IMPORTANT ALERT!

ATWOOD COUPLER INCOMPATIBILITY

NEW FEATURE FOR ANDERSEN WEIGHT DISTRIBUTION HITCH

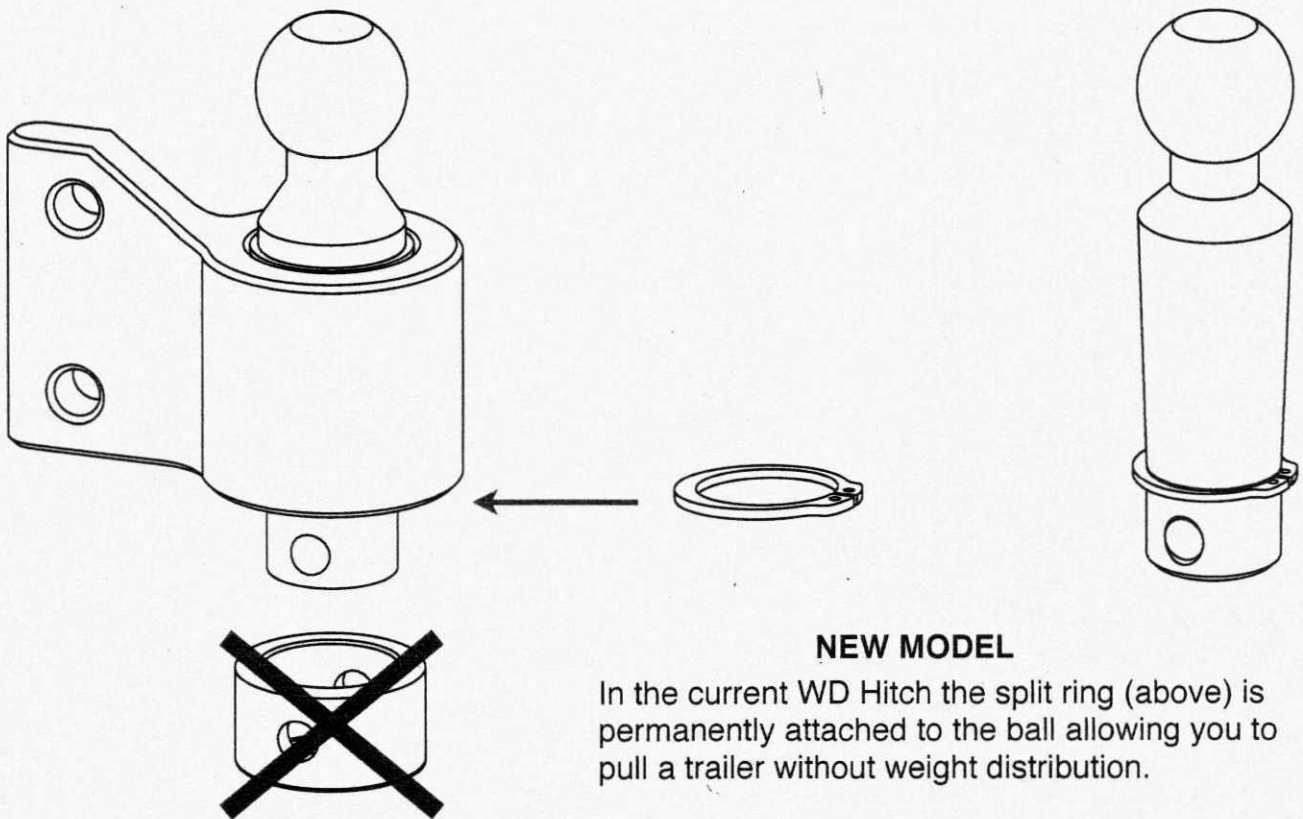
The Atwood 88000 series coupler is currently incompatible with the Andersen 'No Sway' Weight Distribution Hitch.

This potential issue **ONLY** affects the **Atwood 88000 series** (stamped on the coupler as "Atwood model 88xxx" - xxx being any digits). **All other Atwood couplers work fine.** The similarly designed Marvel coupler also works just fine with the Andersen Weight Distribution Hitch.

Because of the particular design of the Atwood 88000 series coupler, when it is combined with the Andersen 'No Sway' Weight Distribution system there is a potential issue in which some couplers can become unlatched over time (due to wear from the internal latch system).

The ONLY solution we endorse at this time is to replace the 88xxx coupler.

Any coupler *other* than the Atwood 88xxx series will work fine.
